Members
Panel on Planning, Lands and Works, and
Panel on Environmental Affairs
Legislative Council of Hong Kong
Jackson Road
Hong Kong

13 December 2005

**Re: Tamar and Central Harbour-front
Over-Capacity in Roadway Provision**

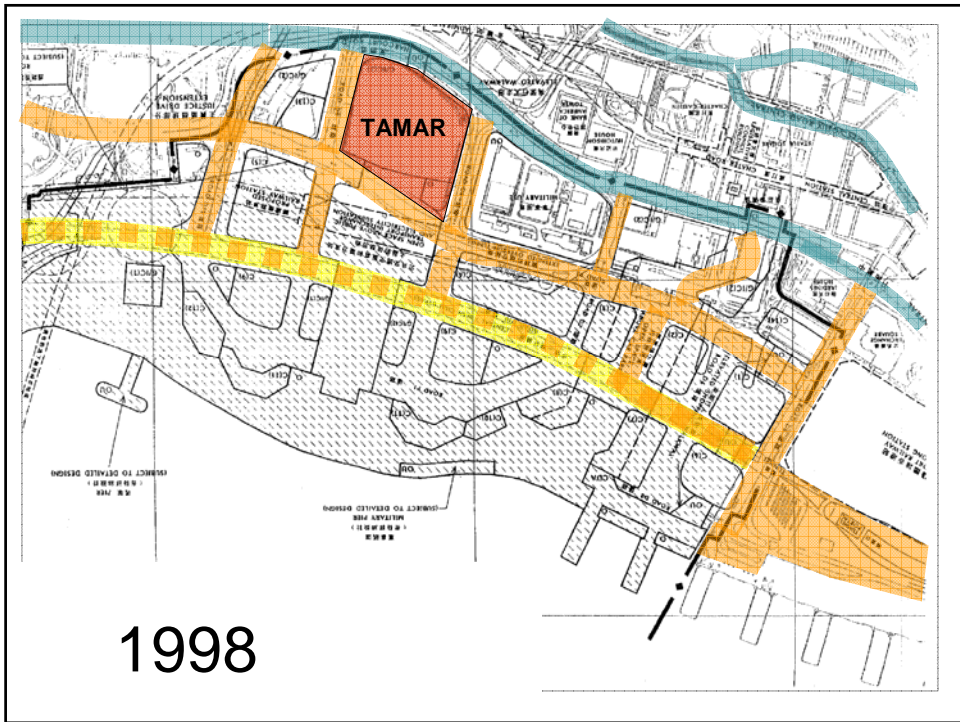
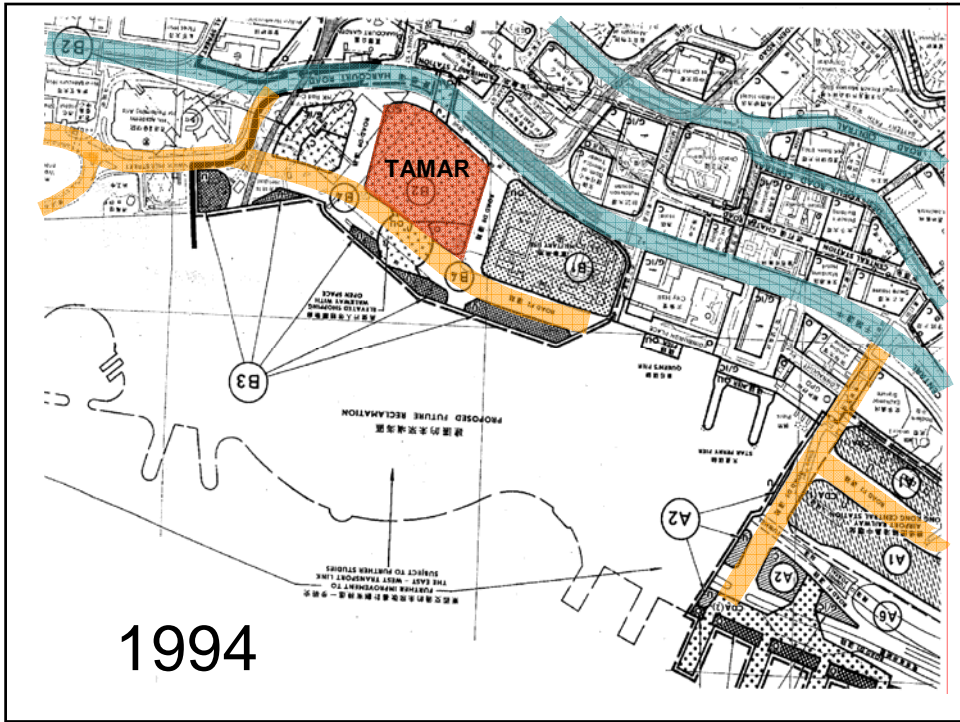
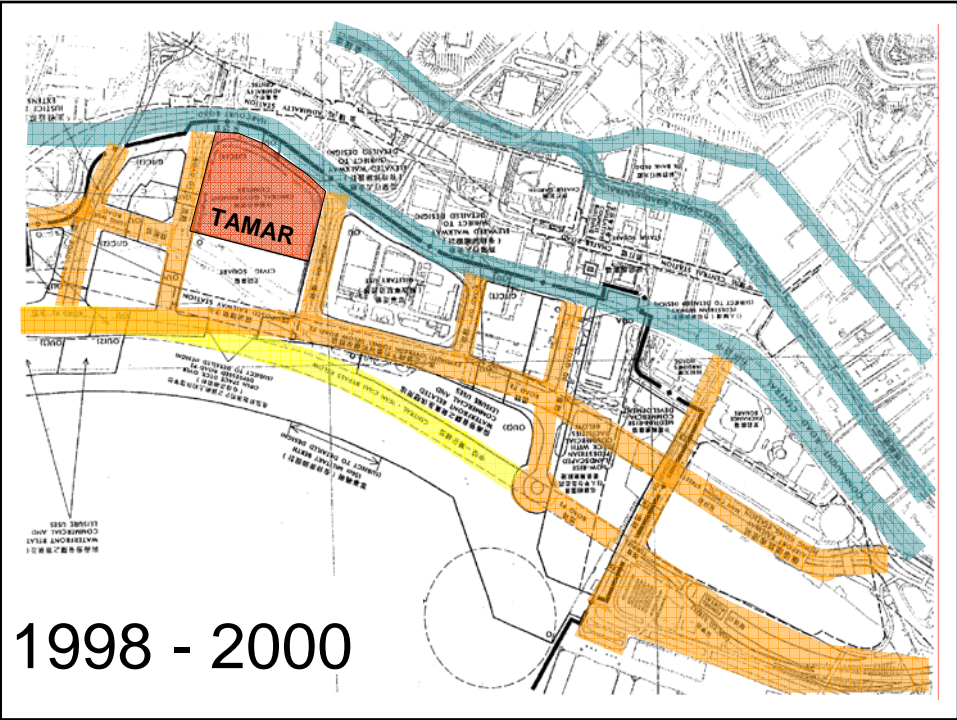
Since 1983 when the Study on Harbour Reclamation and Urban Growth identified a need for reclamation in Central and Wanchai the current densities of road development in the CRIII zone have been more or less fixed. The area has gone through more than half a dozen OZP changes since then but these densities have been maintained from the start. (Slide 2)

In 1994 when the planned reclamation extended 20% beyond its current alignment and the Tamar site was zoned for Commercial Development, the roadways planned for that full reclamation were already starting to be formed. (Slide 3)

The plans for CRIII that were gazetted in 1998 give the clearest indication of what was intended for the site with development blocks including 14 Commercial Development sites and 6 Government Development sites extending towards the waters' edge with a network of major roads to accommodate and service this extensive plan for building construction. (Slide 4)

1998 - 2000

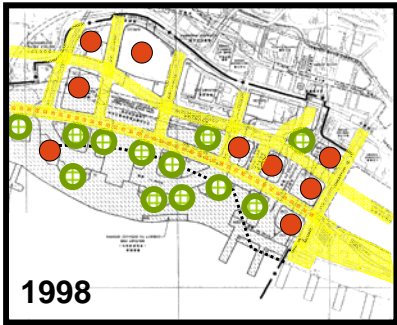
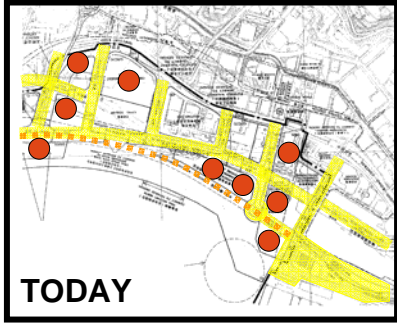
Roads designed to serve development planned in 1998 will still be constructed today, even though the buildings they were planned for no longer exist

STOP! 停止!
THINK! 三思!
REPLAN! 重新計劃!
